TOWN OF CHAPIN
Architectural Review Board Rescheduled Regular Meeting
Council Chambers, Chapin Town Hall
May 14, 2025
6:00 PM

Staff Evaluation of Bank Preliminary

Property Location: Lexington Ave
Tax Map Number: 000721-02-024
Property Zoning District: Village Commercial (VC)
Property Overlay District: Downtown
Applicant: Frank Dougherty

FIFTH THIRD BANK - CHAPIN
203 LEXINGTON AVE, CHAPIN, SC 29306

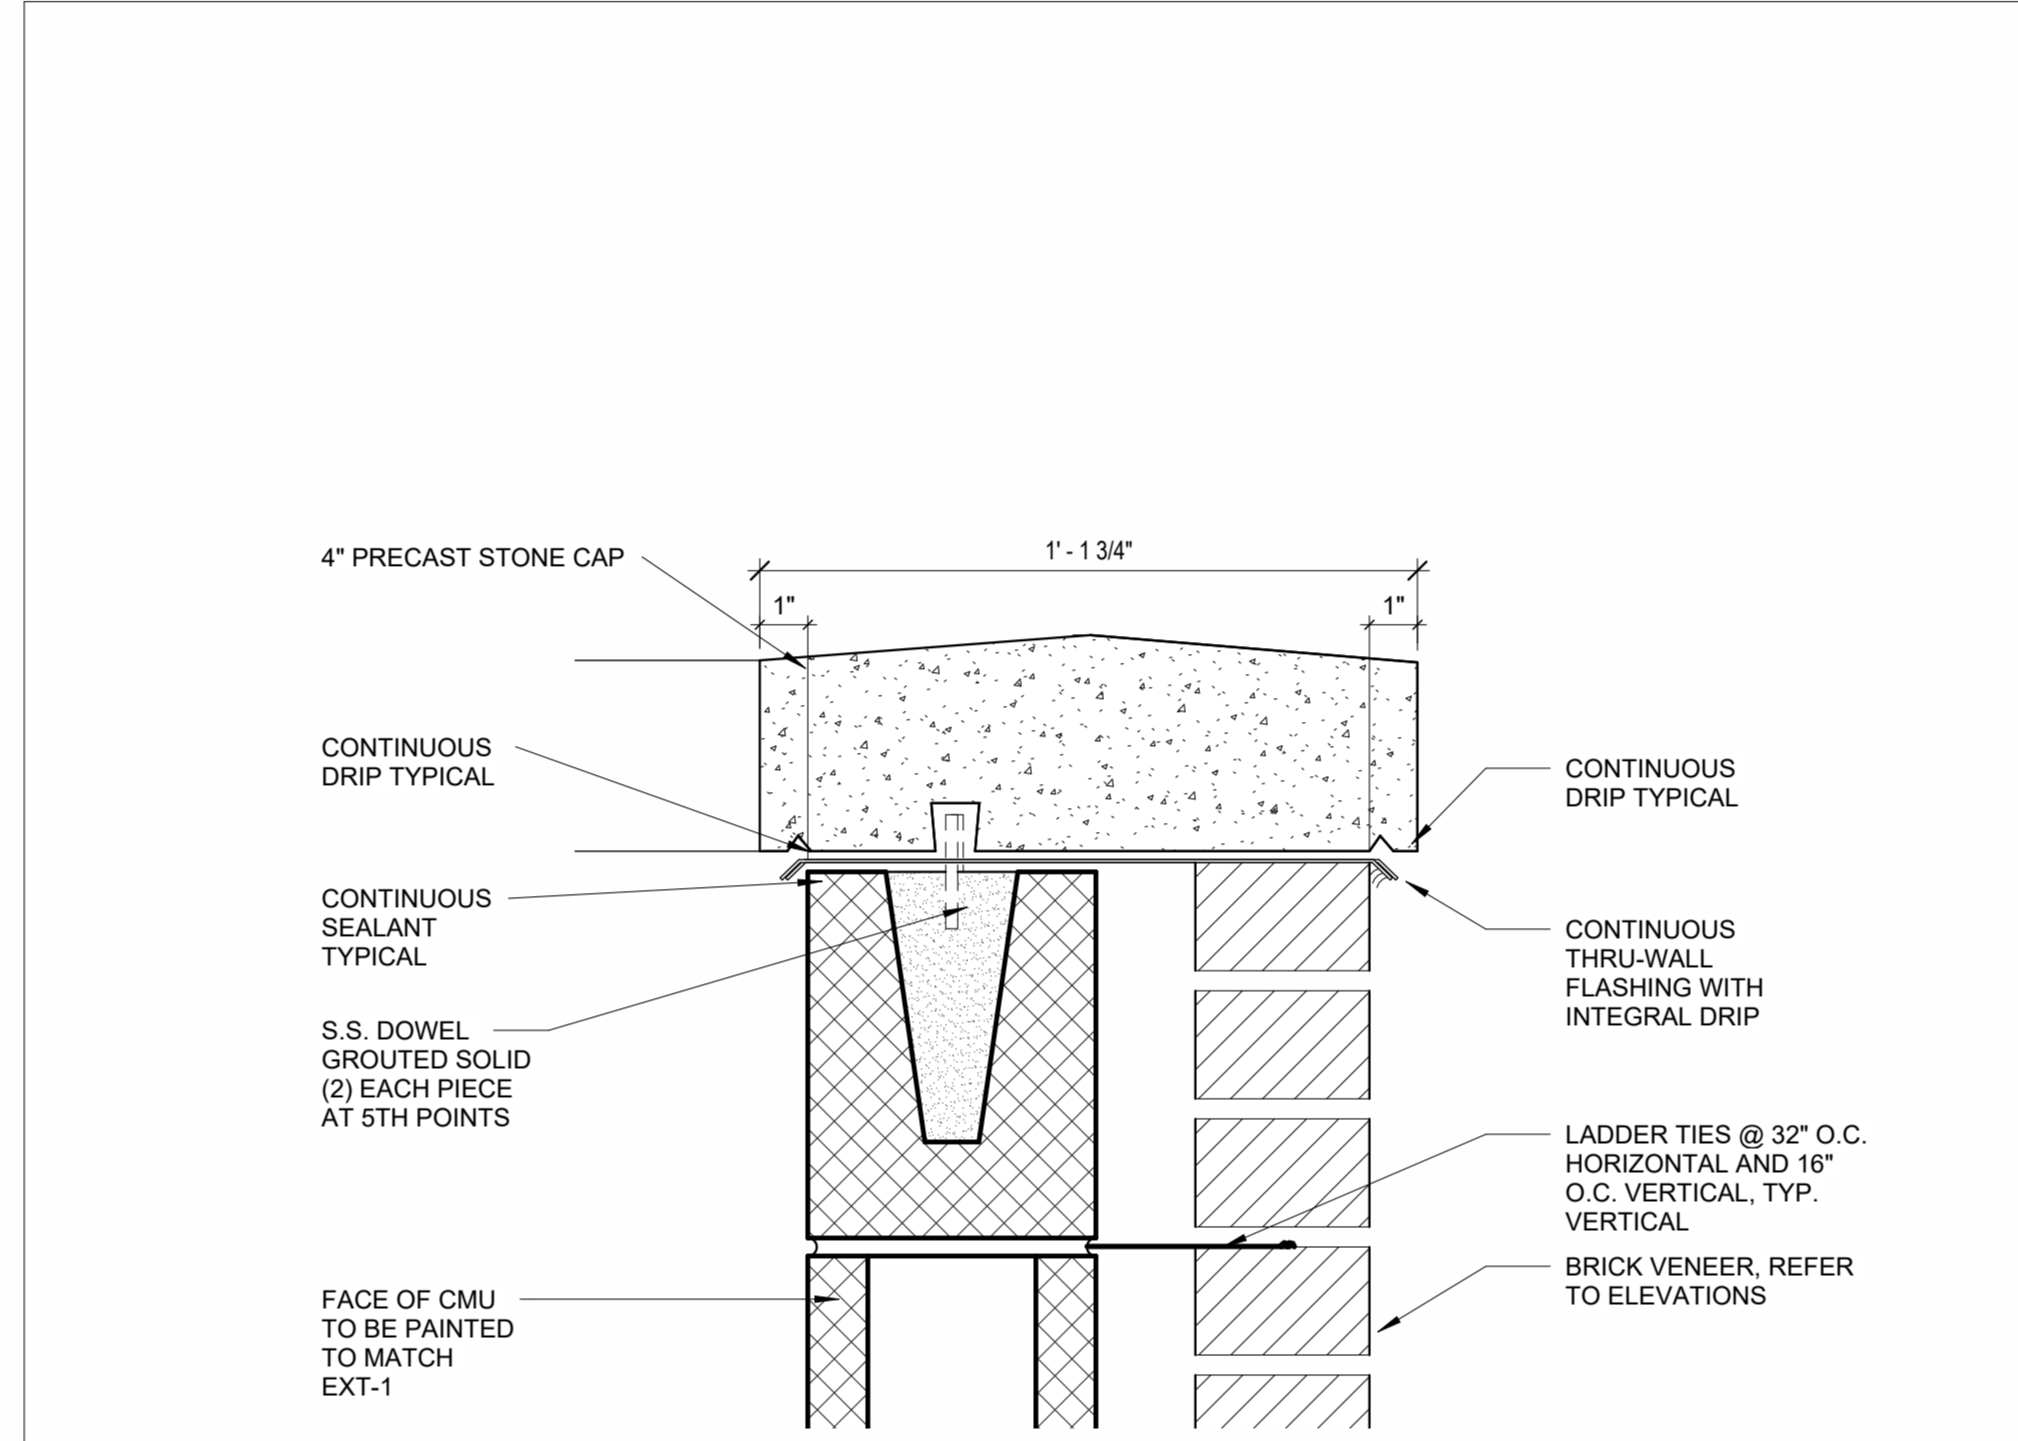
- Exterior color of building that are shown are brick colors are listed as; Steel Gray. **6.11.3.C.3. Mural painting artwork will require approval from Town Administrator and is a completely separate approval process.**

- Architectural design should align with the existing styles and overall ascetics of the downtown area. **6.11.1**
- Street frontage of building does not meet the building frontage requirement of 40% glazing. **6.11.3.C.4. – Asking for ARB reduction**

- Window material and size need clarification. **(6.11.3.c)**
- Roof pitch / slope of the roof. = 5.12. Parapet roof not permitted. **124, 6.11.4.c. Request consideration from ARB**

- Confirm height of parapet is at least 1' higher than mechanical units on Roof. **6.11.7.b**
- Exterior ascetics need to be screened and need to match color of building to blend. **6.11.7.b** (mechanical equip, down spouts, exterior ladder, etc.) Landscaping can work to blend.
